SET Wallplate for the FP975 Programmer

MK9 Wallplate for the FP975 Programmer (Discontinued)

FP975

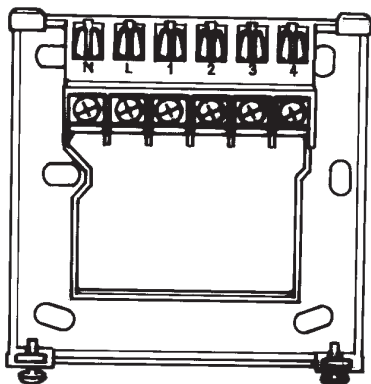
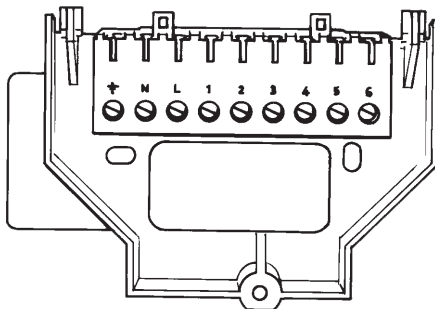
FP975 is a plug-in replacement to MK9, but must be set in MK9 mode using the switch on the rear of the unit.
